NRDC Input on ENERGY STAR Draft 1 Version 8.0 Specification for Televisions

March 31, 2017

Figure 1. Scatter plot of average power vs. screen size, 2016 European Televisions

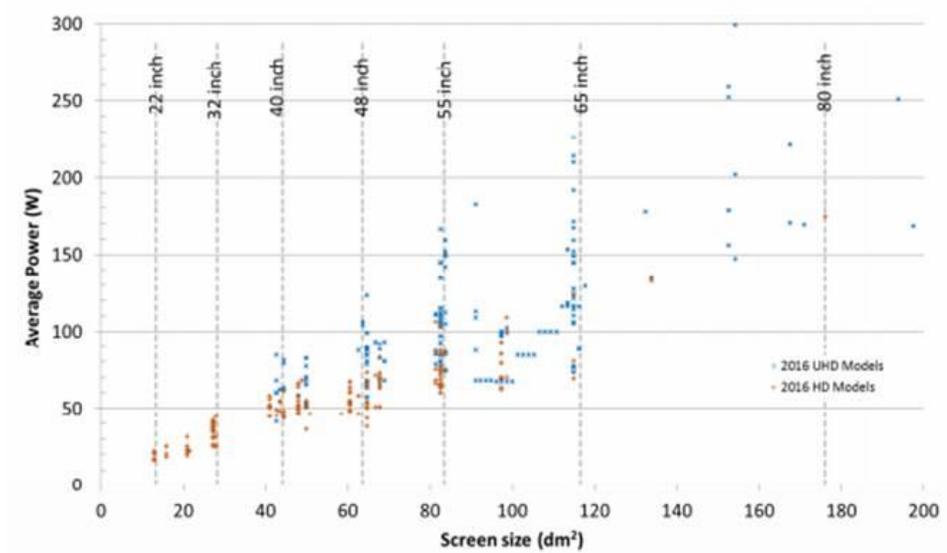
The table below presents a summary of the TV models in the 2016 database and broken down by resolution – high definition (HD) and ultra high definition (UHD). The average specific power¹ was found to be 1.06 for HD displays and 1.20 for UHD displays. This shows that for current televisions on the European market in 2016, UHD requires an average of approximately 13% more power per unit screen area when compared to HD displays.

While we recognize that the new requirements that were added around ABC and MDD may result in higher reported power values for new TVs it’s unclear how

many TVs will no longer qualify or how large of a UHD adder remains warranted.

1. *We recommend EPA take a closer look at its data set and consider reducing the adder down to a level around 25%, which is roughly double the level seen in European TVs.*
2. *If EPA is unable to adjust the adder as part of this specification process we suggest at a minimum that EPA call out in Section 7, Considerations for Future Revision, its intention to review and reduce, as appropriate the UHD adder in its next revision.*
